Standardized Nuclear Unit
Power Plant System

December 3, 1984

SLNRC 84- 0129 FILE: 0278
SUBJ: Steam Generator Tube
Rupture Event

Docket No.: STN 50-482 and STN 50-483

Figure 1-1.2 Reactor Coolant System Pressure

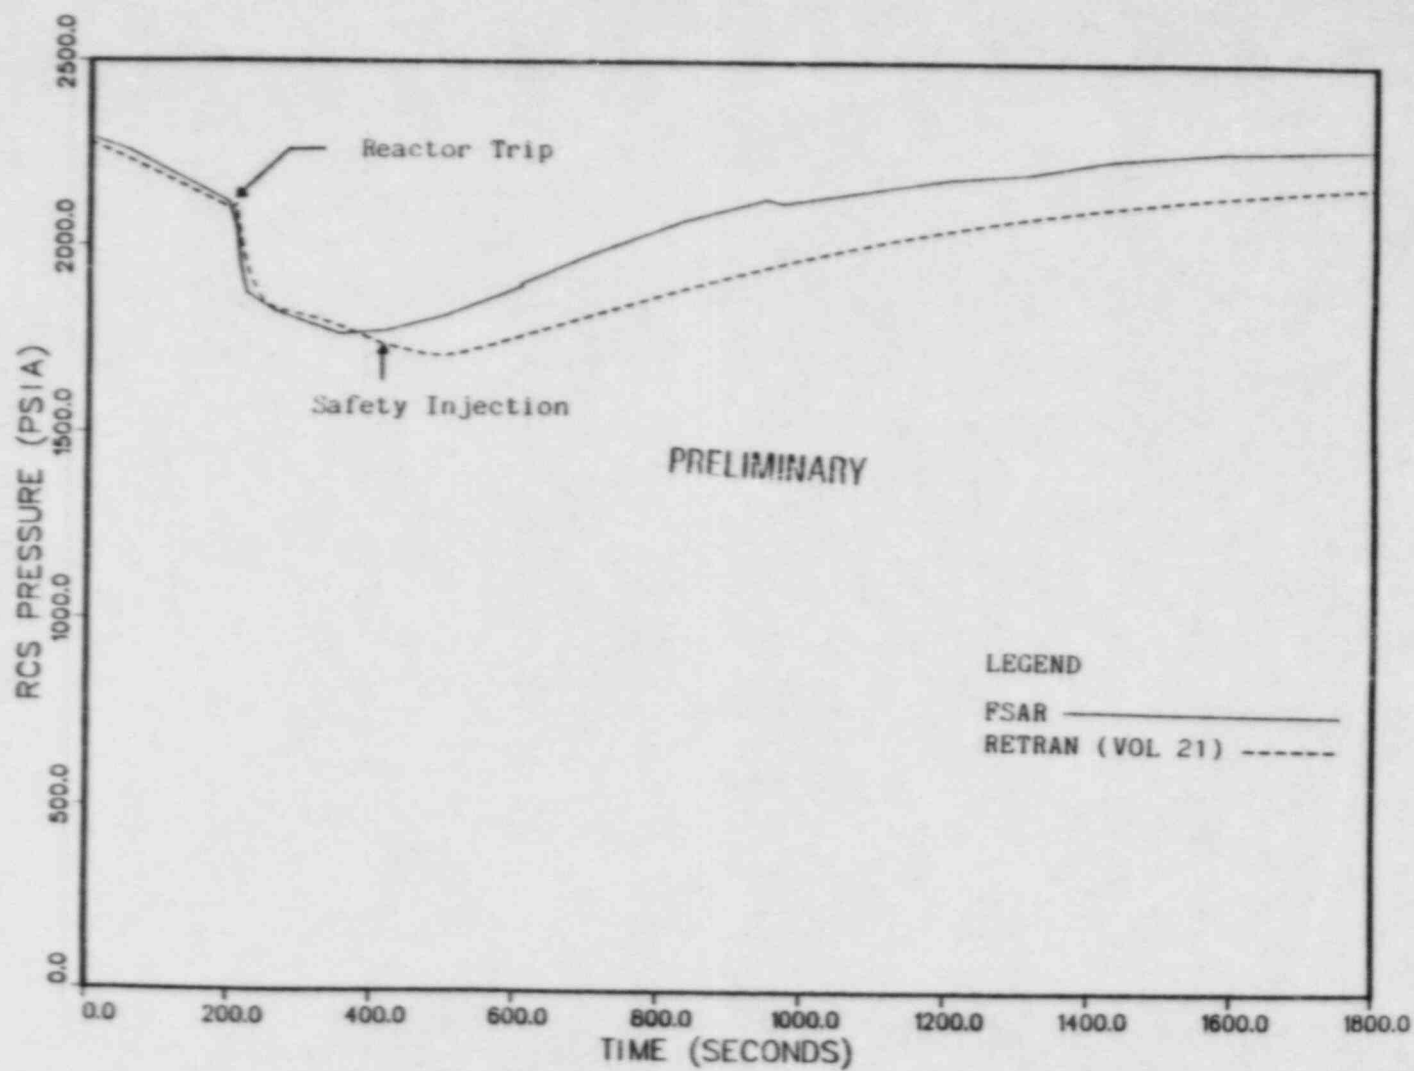
Figure 1-1.2 indicates that under the RETRAN analysis the initiation of safety injection flow does not repressurize the primary system in as short a period of time as the FSAR analysis does. The average RCS temperature (Figure 1-1.4), as predicted by LOFTRAN, reaches a stabilized value prior to safety injection. Therefore, the primary system is repressurized upon the initiation of safety injection. However, the flow coastdown predicted by RETRAN is faster and this causes safety injection to compensate for the shrinkage of RCS

Figure 1-4.8 Reactor Coolant System Pressure (Vol 21)

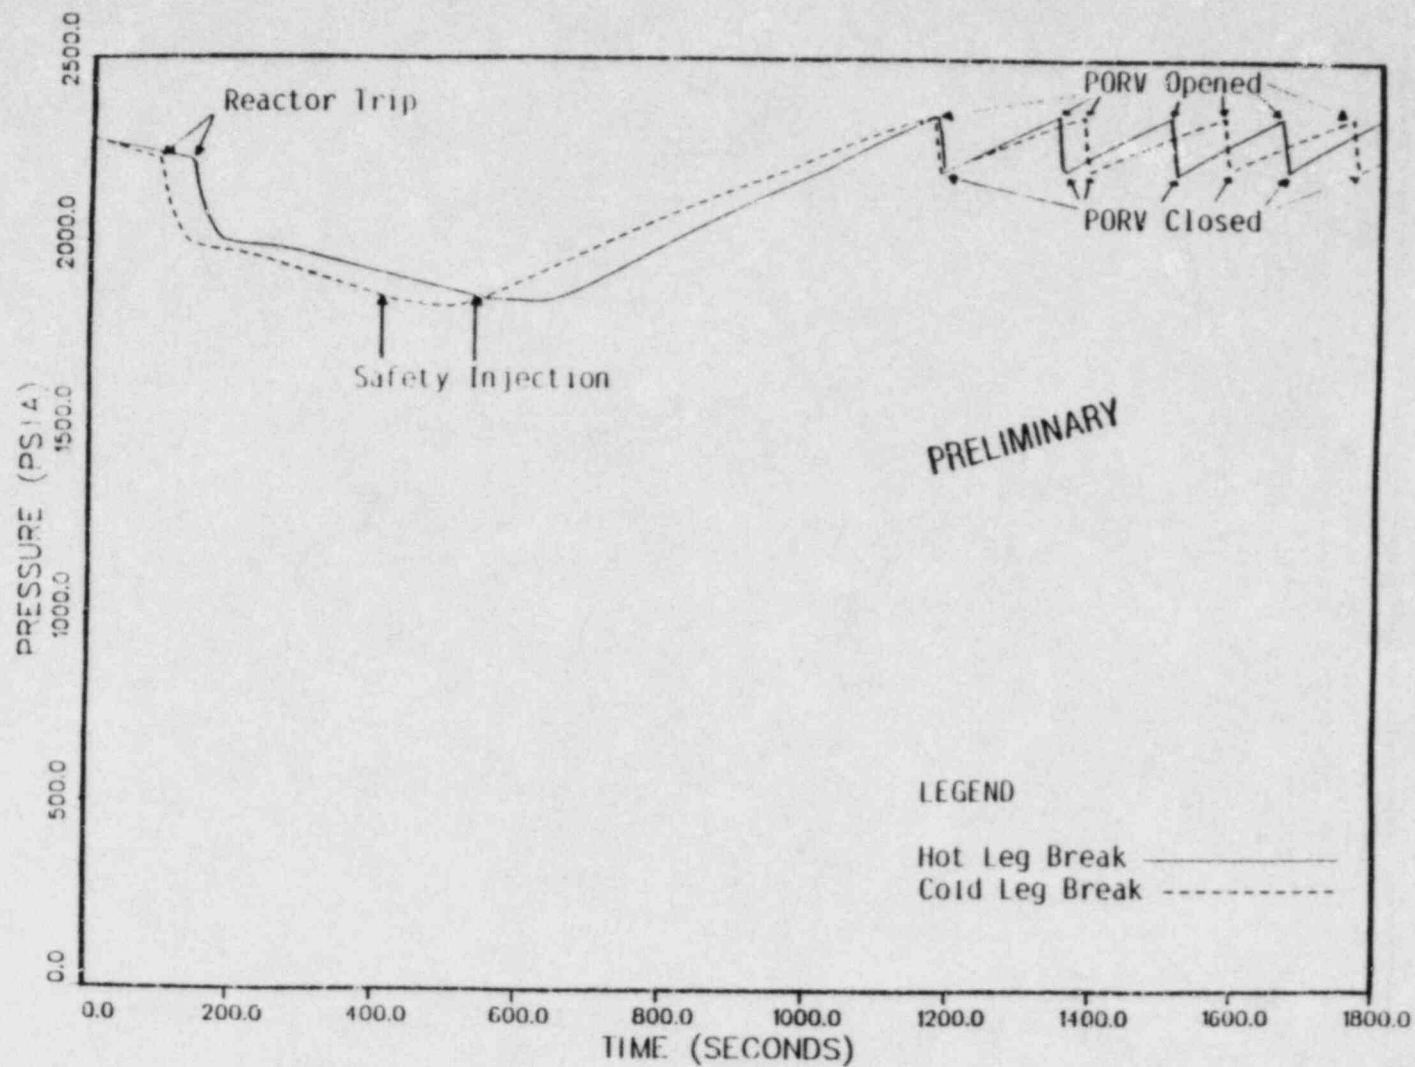
Additional RETRAN analyses utilize a more accurate break flow model represented by the modified Zaloudek correlation. The latter includes pressure drops from the steam generator inlet and outlet plena to the break location. A design basis tube rupture, which is a double-ended guillotine break, is assumed to occur above the tube sheet. The assumptions discussed earlier are used except the reactor trip is controlled by a setpoint associated with the over-temperature ΔT trip. Also, the safety injection signal is initiated by the low pressurizer pressure setpoint at 1860 psia given in the Technical Specifications. Listed in Table 1-1.2 is a comparison of time sequence of events for the tube breaking at the hot leg and the cold leg sides of the steam generator. Results of the parameters in connection with the primary and secondary systems are plotted in Figures 1-1.8 through 1-1.13. Comments on these plots are given as follows:

- 1) The break flow calculated by the modified Zaloudek correlation is directly proportional to two parameters, namely, the fluid density at the break location and the difference of the RCS pressure and the saturated pressure at the break location. Therefore, the break flow through the tube rupture at the cold leg side is higher than that at the hot leg side (Figure 1-1.11).
- 2) At the reactor trip, there is a sharp increase in break flow for the hot leg break due to a decrease in temperature at the break location (Figures 1-1.10 and 1-1.11).
- 3) Upon the repressurization of the primary system, the pressurizer power-operated-relief-valve (PORV) is actuated (open/closed) in response to the pressure changes (Figure 1-1.8).
